PERMIT # OSWP-2022-1984

SEPTIC: IMPROVEMENT PERMIT / AUTHORIZATION TO CONSTRUCT / OPERATION PERMIT / EXISTING SYSTEM

APPLICANT / OWNER: SIMON FAMILY REVOC TR | APPLICANT ADDRESS: 973 Linwood Rd, Mooresville, NC 28115

SITE ADDRESS: 975 LINWOOD RD, MOORESVILLE, NC 28115 | PHONE: (734) 239-4200 | ALT. PHONE:

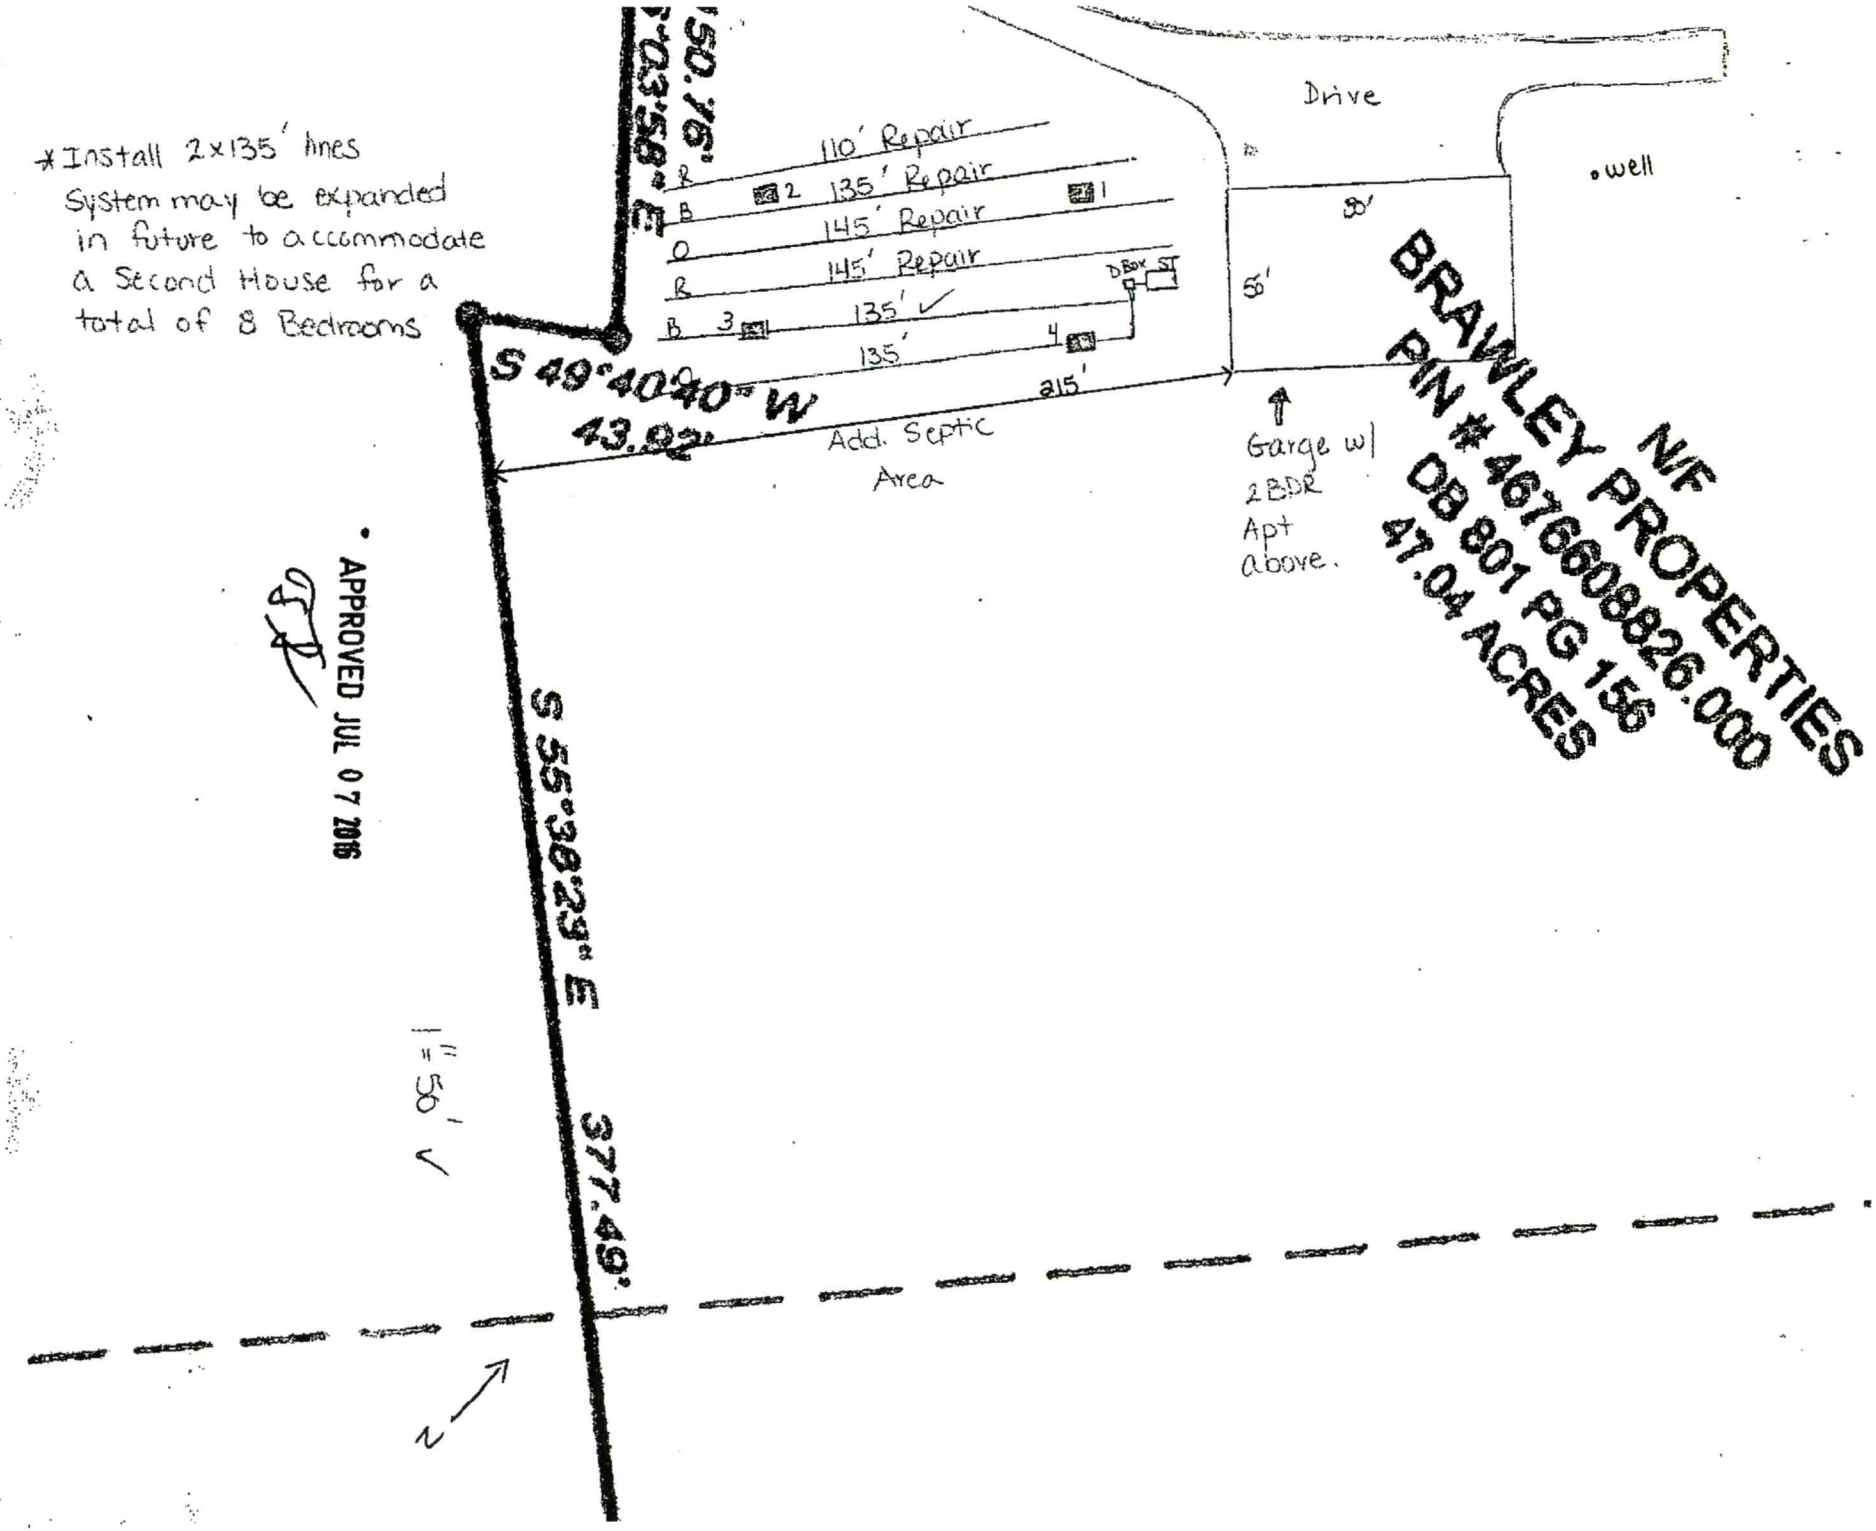
Comments / Conditions: Currently apartment over garage building is unfinished & contains no bedrooms. This permit will allow owner to connect a 2 bedroom home to the existing system. If the apartment over the garage is ever finished, septic system must be expanded - this will require a new soil evaluation & system design approval.

INITIAL SITE SKETCH

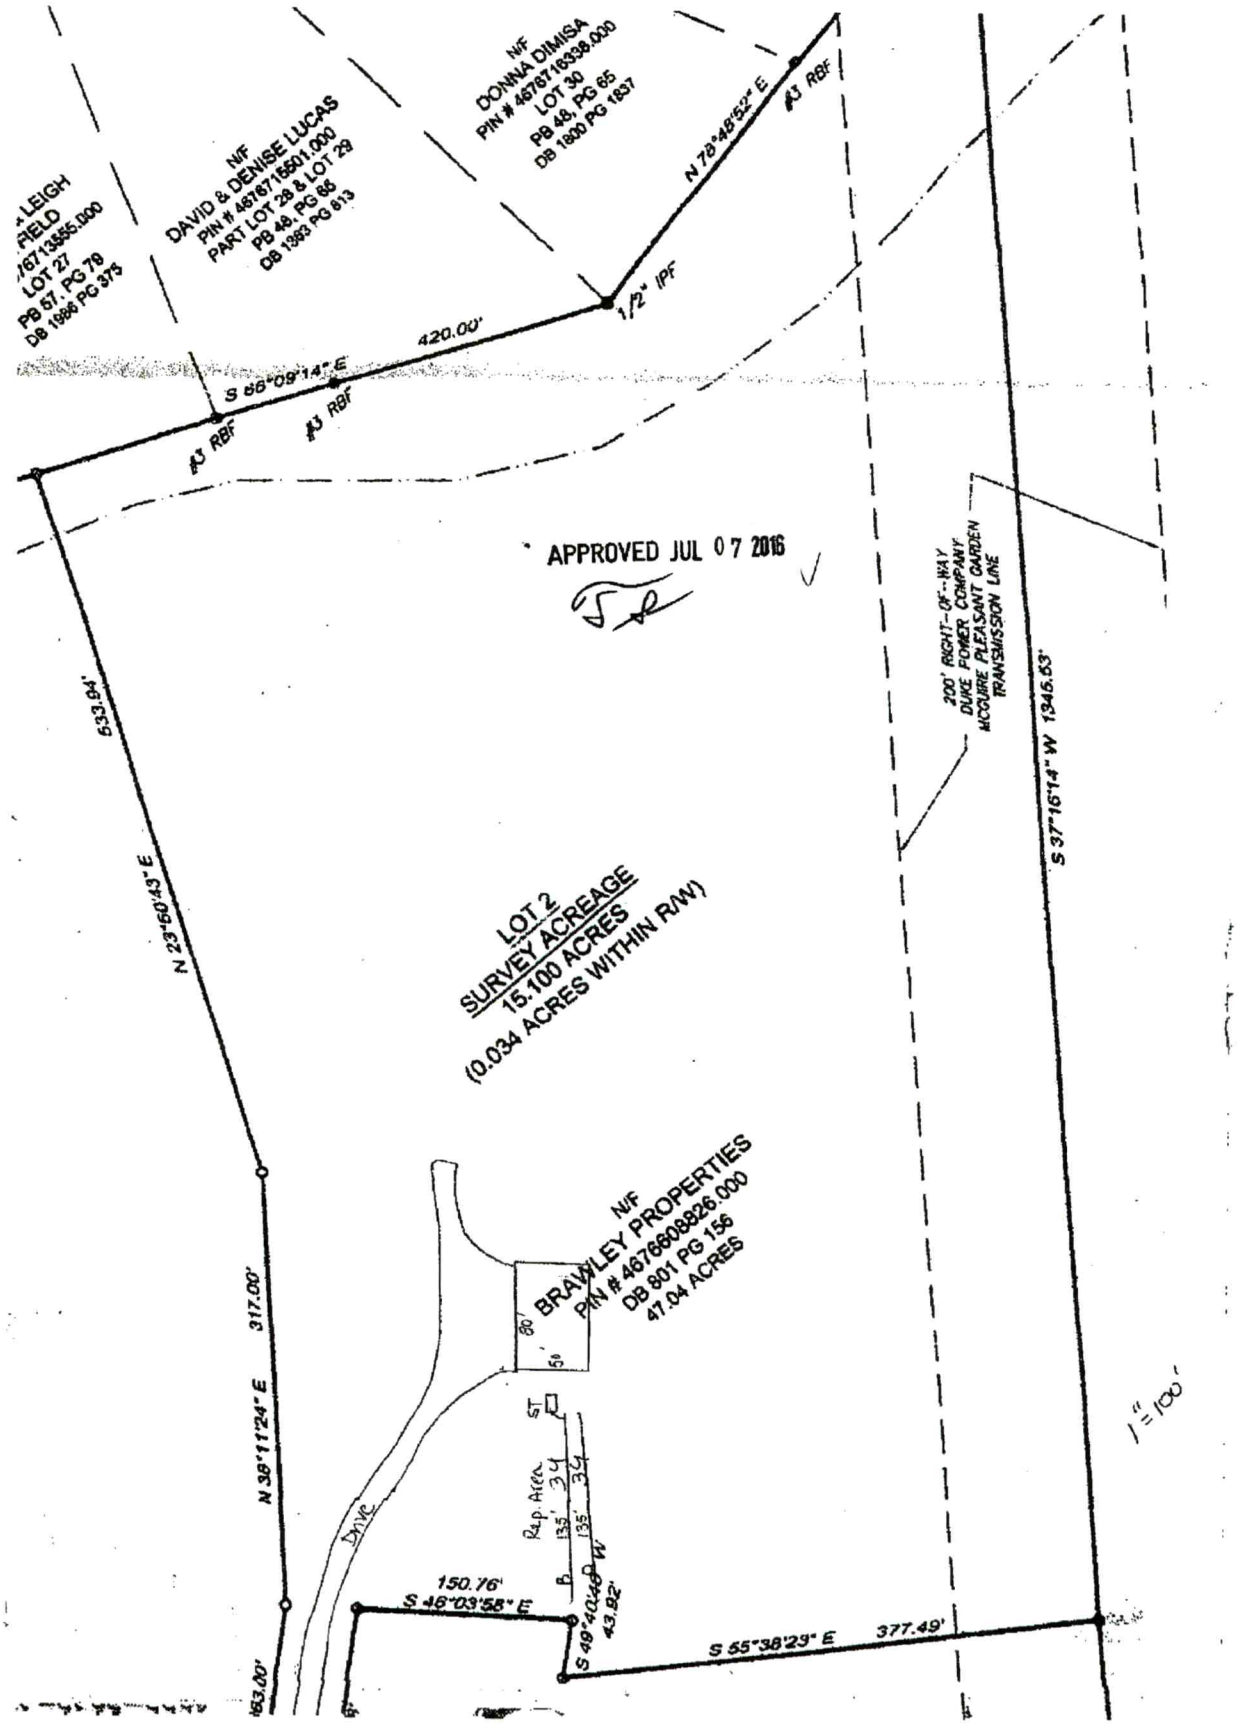
Comments / Conditions: Follow all N.C. septic rules. Recommend pumping septic tank every 3-5 years. A reference to a future ≥ 6-Bedroom house being "tied into" the existing field, any such change in use must first be applied for + meet the current rules + receive health department approval prior to construction.

No house started at time of inspection.
